# UNITED STATES PATENT AND TRADEMARK OFFICE

10/565,528

<b>Office Action Summary</b>	<b>Application No.</b> 10/565,528	<b>Applicant(s)</b> GRANT, JON	
	<b>Examiner</b> MARINA TIETJEN	<b>Art Unit</b> 4177

**Figure A**

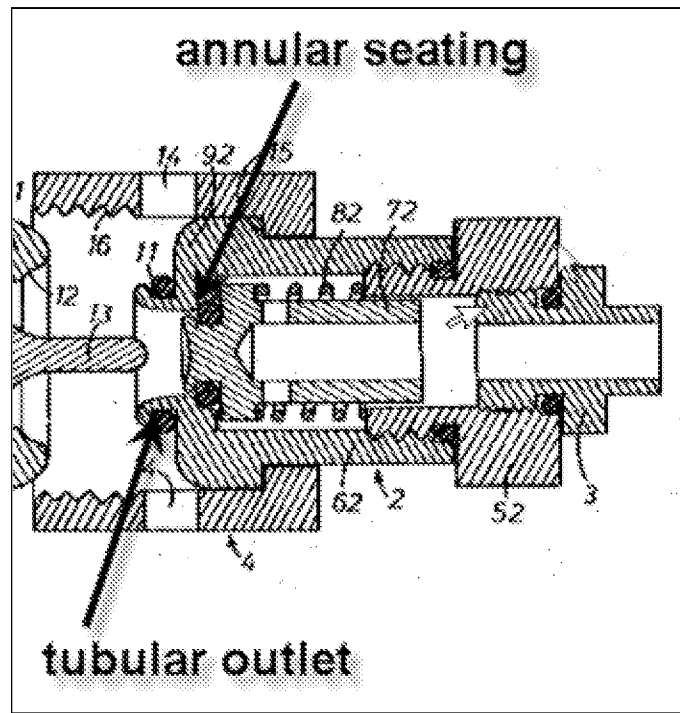
Regarding Claims 1, De Visscher discloses a valve 2 (Fig. 1) capable of selectively providing access to a supply of drinking fluid within a portable flexible container comprising a tubular body 62 (Fig. 1) having at one end a stem 3 (pipe, Fig. 1), capable of being inserted into an opening in communication with a container, and at its other end an outlet (Fig. 1) through which fluid from the container can leave the valve 2, a piston 72 (Fig. 1) mounted for sliding movement within a central bore of the body 62 (Fig. 1) and resilient means 82 (Fig. 1) for urging the piston 72 into engagement with an annular seating (see Fig. A below) positioned at the bore end closest to the outlet, and

Regarding Claim 9, De Visscher discloses the outlet is formed in a tubular end piece (shown in Figure A below) of the body 62.
